WASTEWATER MANAGEMENT STUDY

APPENDIX II COMMENTS

CLEVELAND - AKRON METROPOLITAN

THREE RIVERS WATERSHED AREAS

FIGURE 1

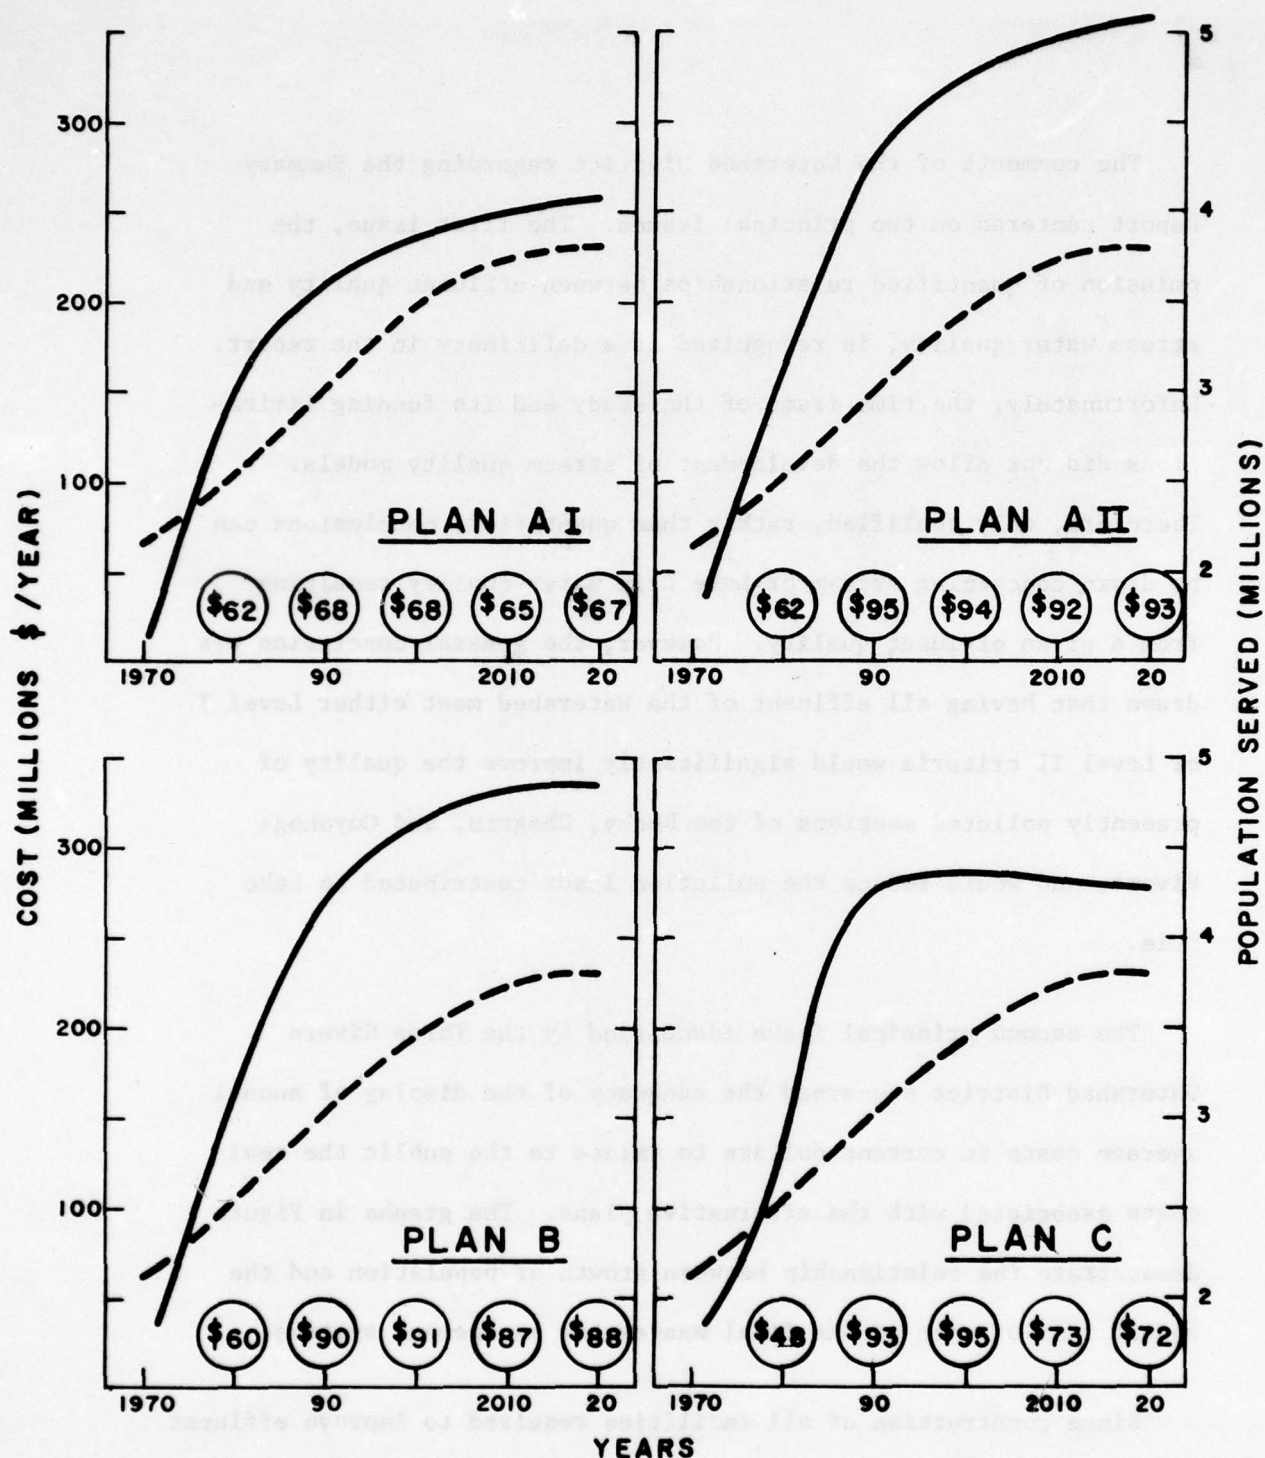
The second principal issue identified by the Three Rivers Watershed District concerned the adequacy of the display of annual average costs in current dollars to relate to the public the real costs associated with the alternative plans. The graphs in Figure 1 demonstrate the relationship between growth of population and the annual cost of each of the final wastewater management systems.

increased population and component replacement. The average annual per capita costs for the four plans during the period of 1990 through 2020 are \$67 per year for Plan A-I, \$96 per year for Plan A-II, \$89 per year for Plan B, and \$81 per year for Plan C.

The average per capita costs depicted above must not be interpreted as actual sewer charges. The actual residential sewer charges will depend upon the surcharge rate applied by the municipalities to industrial dischargers and the extent of recycling achieved by industry, which may result in reductions in residential charges as much as 30 percent. In addition, the proportion of the sewer charge which is attributed to the installation and maintenance of local collection systems, which discharge into major transport trunk sewers, are not reflected in these costs.
